pd-trigger — Design Document

ai-ee v1 pipeline

Board review (P8 adversarial) - pd-trigger

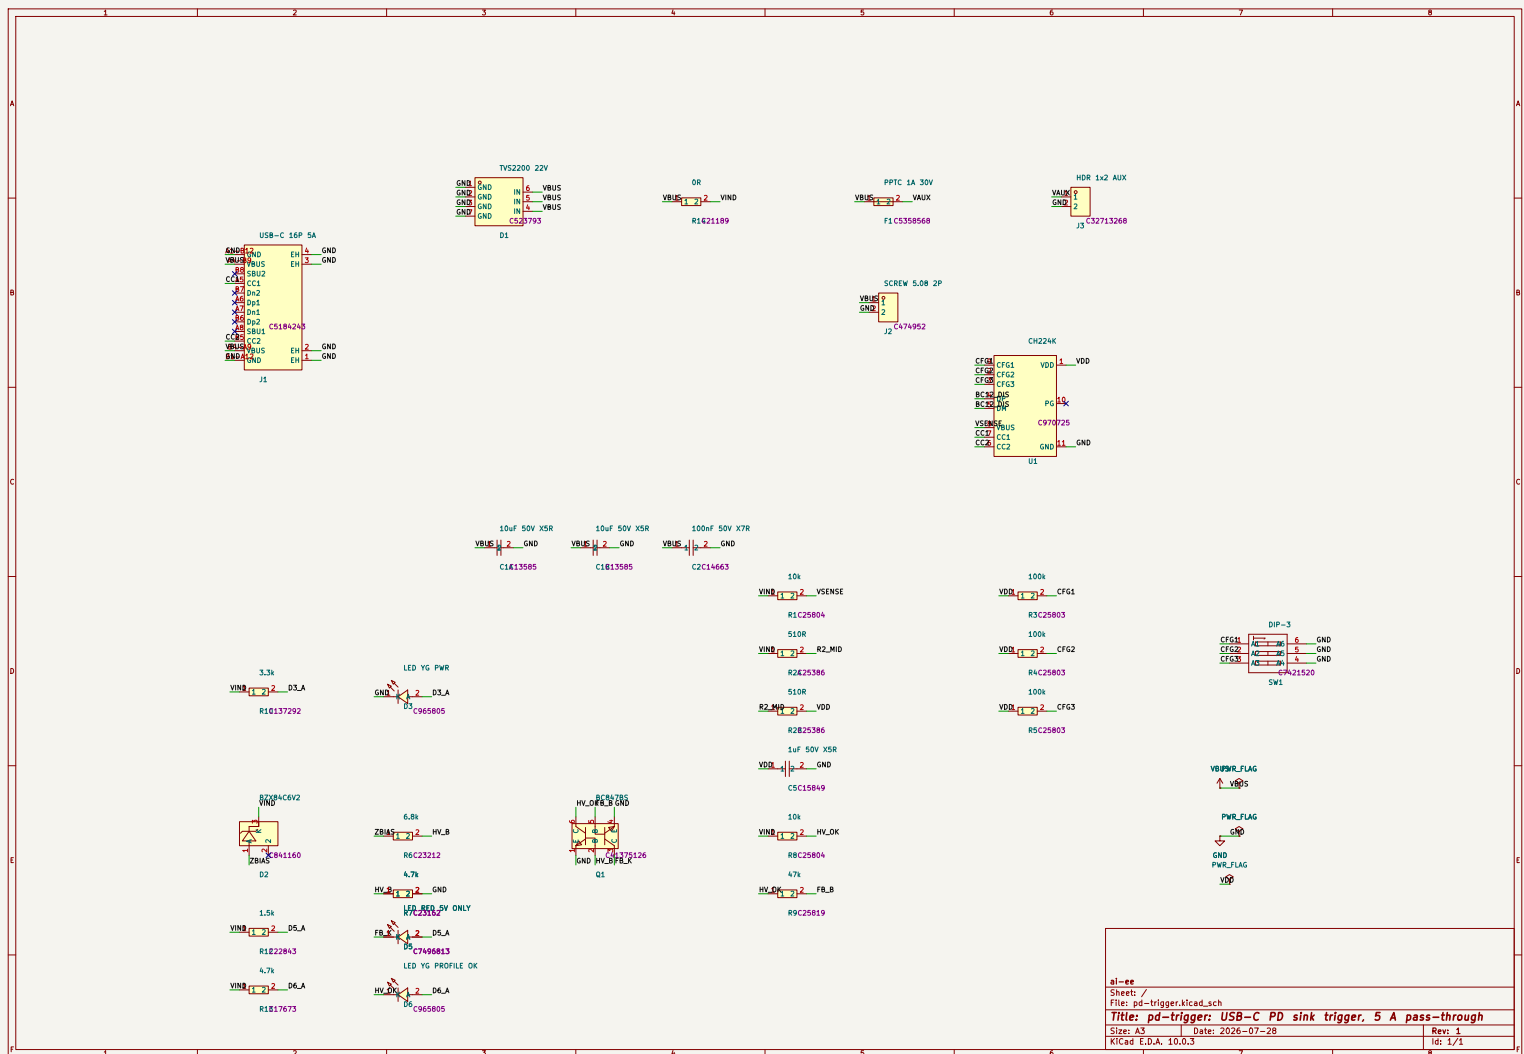
W1 dp-dm-short-at-chip: architecture’s PD-only short (`/BC12.DIS`) ACCEPTED by the reviewer as hardware-SAFER than the datasheet’s connector wiring (removes a 21V-onto-3.8V-abs-max fault path). Cost: no QC/BC legacy support - the board is “PD sources only”; goes on B.SilkS + order docs. W2 vdd-worst-corner: true worst case 0.979mA at 4.4V low-line all-straps- closed vs unpublished CH224K IDD - bounded by WCH’s own reference circuit; V1 bring-up step: measure VDD at the 5V profile; contingency = both 510R -> smaller (documented floor 600R total). Bring-up addenda: buzz out Q1 E/B/C once (clone PDF JS-gated; Nexperia- standard pinning verified as the compatibility claim).

reports/render_final/top.png

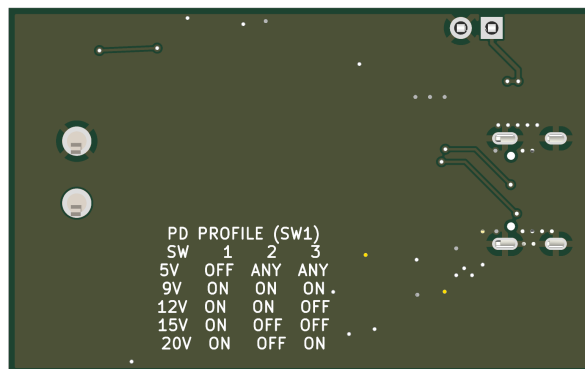
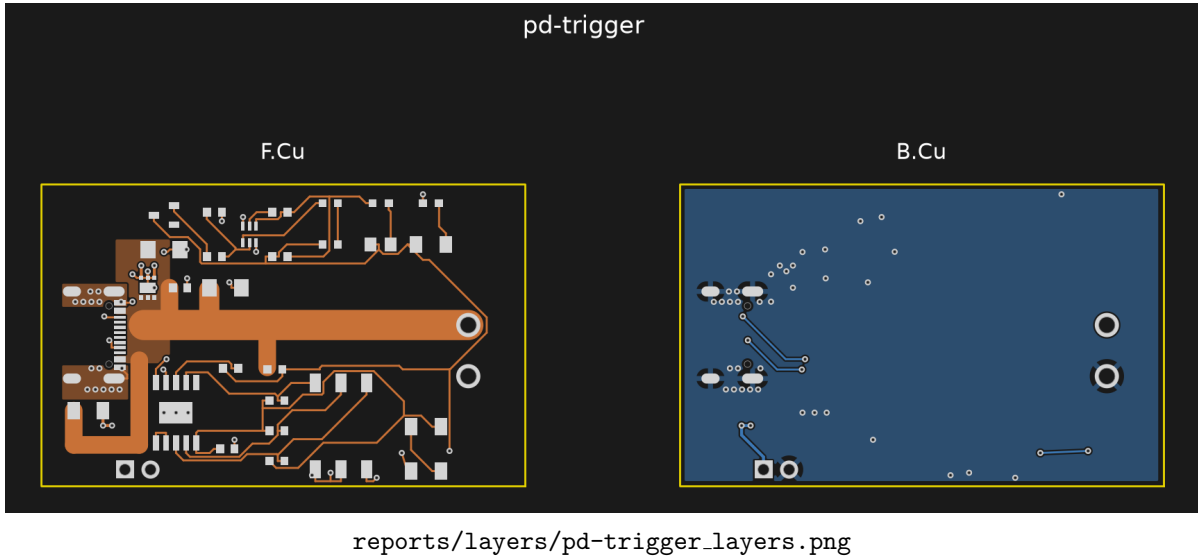
E1 - 5 A return chokes at J1's GND contact pads (error, checker-blind by design D7)

The 4 GND cable contacts land on two merged SMD pads (F.Cu only): A1-B12 at (17.63,39.31) and B1-A12 at (17.63,45.71), nominally 2.5 A each at the 5 A rating. Their ONLY copper into the B.Cu return pour:

- A1-B12 (top): a 0.2 mm wide, 2.7 mm long F.Cu chain (3 segments) into shell pad 1's THT barrel, plus one 0.6/0.3 via whose annulus grazes the pad corner by ~0.05 mm (etch-tolerance-level). 0.2 mm at 2 oz = 0.80 A capacity at 10 C rise (pipeline model); at 2.5 A the same model gives ~133 C rise (short-neck heatsinking will moderate this, but it is a >3x overcurrent on the model's own terms). ~13.6 squares = 3.3 mohm.
- B1-A12 (bottom): a 0.2 mm x 1.3 mm trace into ONE 0.6/0.3 via. The board's own via budget (constraints via_amps 0.5) says 2.5 A needs 5 vias; there is 1. Shell pad 4 sits 0.32 mm away but is NOT connected on F.Cu - its copper does not help.

Architecture D7/power_tree structural requirement ">= 10 vias at J1's GND pads" (the stated substitute for keeping GND out of power[] so check_current stays quiet): not delivered. DRC cannot see it (0.2 mm is netclass-legal), check_current cannot see it (GND undeclared), check_return_path no-ops (no high_speed key). Failure mode: sustained 5 A at any profile heats the two necks far past the 10 C design intent; long-term trace/joint fatigue, intermittent ground, and full return current cascading onto the surviving 0.2 mm chain. Fix is cheap at P9: an F.Cu GND spandrel bonding each contact pad to its shell pad (the VBUS pour top edge is at y 39.7 - the strip above it, and the strip x < 17.2 plus the region south of y 46, are free) plus 4-5 vias per side.

E2 - Safety/waiver silk markings absent (error, promised artifact) Board-wide gr.text count is ZERO; B.SilkS carries nothing at all (both B.SilkS references in the file are the stackup layer table). Missing, each one a written promise:

- AUX 1A MAX + V+/GND at J3 (P0 answer 4 "silk-marked", V10). F1 makes overload safe-by-hardware, but polarity of the 2-pin aux header is unmarked.
- PD SOURCES ONLY (ERC waiver W1's standing condition: "goes on B.SilkS + order docs"). The waiver's silk half is currently unfulfilled.
- J2 screw-terminal polarity. Trunk lands on J2 pad 1 = the LOWER screw (board-bottom side); nothing anywhere tells the bench user which screw is V+. Reverse-wiring a load on a 100 W output is the single easiest field mistake this board can cause.

E3 - User-interface silk absent (error, promised artifact)

- The five-row profile table on B.SilkS - D3 calls silk "the user interface" and specifies the table verbatim; the bottom is a clean pour with room. Without it the ON/OFF-to-voltage map exists only off-board; a user WILL set 9 V expecting 12 V by trial and error. (Fail-safe floor: any wrong guess >= the 5 V fallback, and OFF-fail = 5 V - the mistake is bounded but real.)

- LED legends PWR / 5V ONLY / PROFILE OK (D4/V10): the render shows refdes D3/D5/D6 only. The entire P0-answer-6 "visible fallback indication" scheme is mute without the words - a lit red LED labeled "D5" indicates nothing.

- Cable disclaimer "20V @ 5A needs a 5A e-marked cable and a 100W source" (V10 lists it as silk; power_tree s7 allows documentation - at minimum it must reach the order docs at P9/P10, which do not exist yet; fab/ is empty).

W1 - J1 mouth recessed ~0.4-0.5 mm behind the board edge (warning, flagged at P6) Courtyard/silk front edge $x = 10.18$ vs board edge $x = 9.8$. USB-C receptacles are normally flush-to-overhanging; a recessed mouth lets thick/molded plug overmolds butt the board edge and hold the plug fractionally short of latch - intermittent CC, no PD, "works with some cables". On a bare bench board with arbitrary cables this is a real annoyance risk. Fix: nudge J1 -x 0.5-1.0 mm at P9 (pour edge follows; nothing else in that corridor), or accept and note in order docs.

W2 - Outline 48 x 30 mm exceeds the architecture's hard ceiling (warning, drift) Edge.Cuts = (9.8,27.51)-(57.8,57.51) = 48 x 30 mm. D9: nominal 45 x 25, "hard ceiling 48 x 28 mm"; 30 mm violates D9's own ceiling by 2 mm even though it equals P0 answer 5's literal +20 % (40x25 -> 48x30, +44 % area vs the brief's target). No digest discloses the growth past D9. Consequence is cost/footprint only, but it must be disclosed to the user at the checkpoint rather than discovered.

```
# P8 digest (pd-trigger)
verify PASS 8/8 first try. Fable reviewer: 4 err + 2 warn. Copper errors
REAL: 5A RETURN choked at J1 GND pads (0.2mm necks/0.80A, 1 via) - rebuilt
w/ priority-1 F.Cu GND lobes (connect.pads solid) + 15 new 0.6/0.3 vias ->
5.68A/4.70A per pad, 16 vias (D7 >=10 met). Removed 2 stitch vias 0.121mm
from THT drills - LIVE-PROVEN KiCad DRC blind spot (via-drill vs same-net
pad-drill never checked, finding 34). Silk errors: 17 texts added; agent
CORRECTED the orchestrator's B-table spec (raw CFG bits would be inverted
vs ON=GND switch reality - printed switch positions). Warns: mouth recess
-> order docs; outline 48x30 deviation recorded; C1B channels waived w/
numbers. Re-gates: drc_routed 0/0, verify 8/8. H4 AUTO-approved.
```
